File 1989-0007

Name: Calvary Bible Church – Conditional Use – 27.5 Rd. & F.25 Rd.

RE: #7-89 Conditional Use-Calvary Bible Church
Response - Review Sheet Summary

SITE PLAN
1/4" = 1'-0"

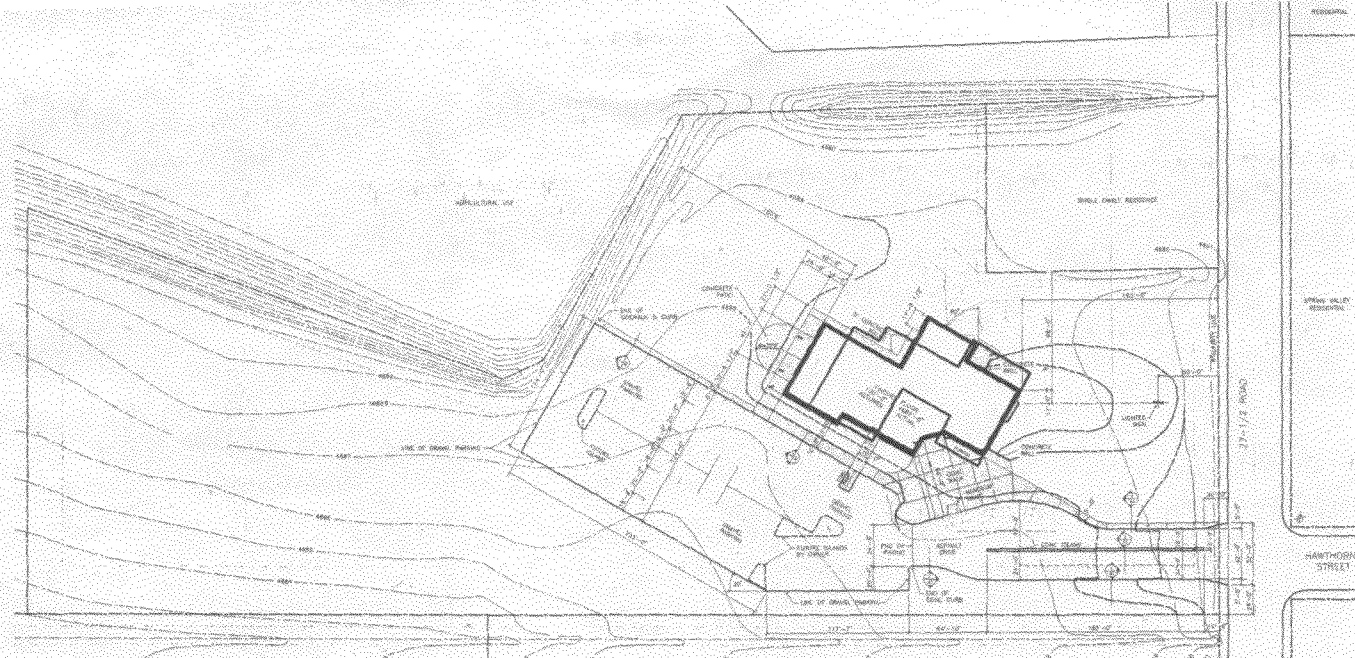
I have reviewed the final site plan for the proposed church and have the following comments:

1. Grades and elevations should be shown on all site pavement and concrete construction to insure proper drainage of the paved surfaces. Elevations should be shown on proposed contours on the east side of the building. Areas which are to be landscaped should be designated on the plan.

2. The parking lot should be graded and designed such that on site detention of storm runoff will be provided at such time that the parking lot is paved. On site detention is required for all runoff in excess of historic (undeveloped) conditions up to and including a 10 year storm event. This detention could be provided within the parking area or west of the parking area with some type of outlet control to the existing drainage channel. Historic and developed runoff rates should be calculated using the rational method and shown on the plans.
